**PLANNING COMMISSION
STAFF REPORT**

August 16, 2018

AGENDA ITEM: Planning File 110-18-MDA/CU (092-17-DA/CU): a public hearing of modifications to the approved development application and conditional use request for the Library Lofts multi-family residential project

4 EAST ELEVATION
SF=110'

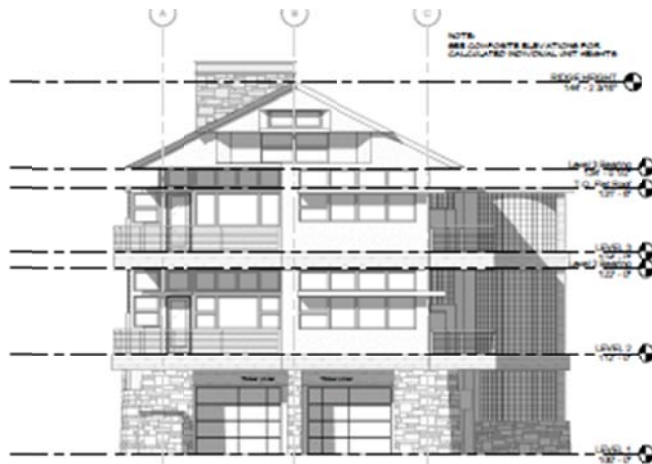
The south and east facades are street facing facades. No more than 66% of the length of the wall lines along these facades is proposed to be constructed within the same plane. The east roof ridgeline appears to exceed sixty-six percent (66 %) along the same geometric plane. Staff has suggested a condition that the applicant shall revise the proposed plans to comply with Frisco Town Code, Section 180-18.1, Main Street Overlay District, Standard 2.2, prior to submitting building permit application. With this suggested condition, the application meets this standard.

9. *The applicant shall revise the proposed plans to comply with Frisco Town Code, Section 180-18.1, Main Street Overlay District, Standards 2.2 and 4.2 prior to submitting building permit application.*

August 2018 Roof Plan

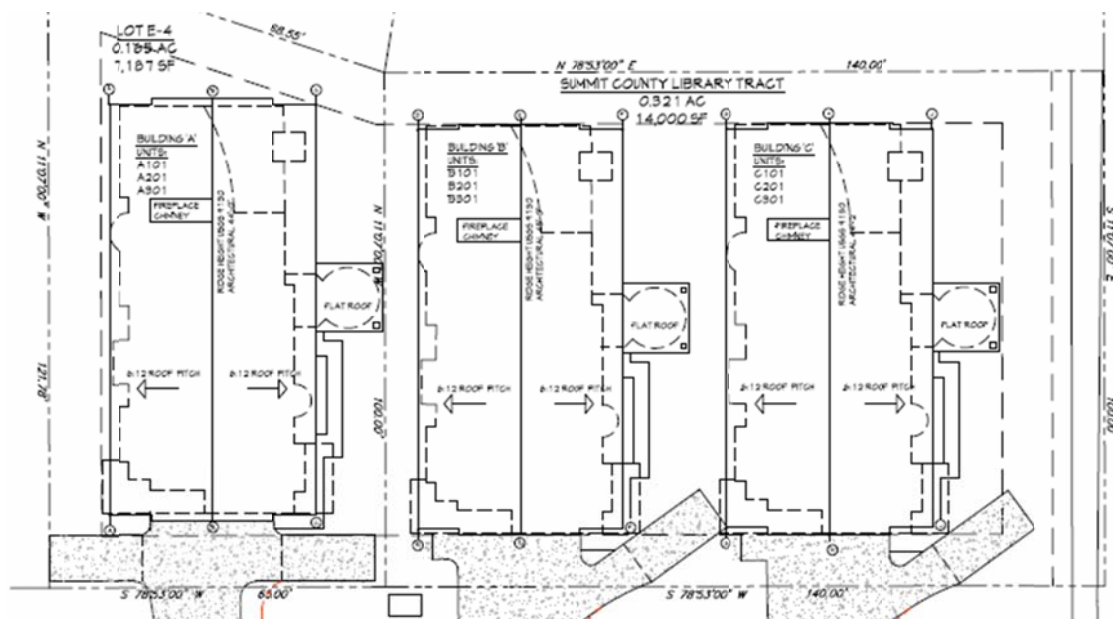
The proposed structures each provide 6:12 pitches. The application has not utilized the use of dormers to break up the expanses of roof. Staff has suggested a condition that the applicant shall revise the proposed plans to comply with Frisco Town Code, Section 180-18.1, Main Street Overlay District, Standard 4.2, prior to submitting building permit application. With this proposed condition, the application meets this standard.
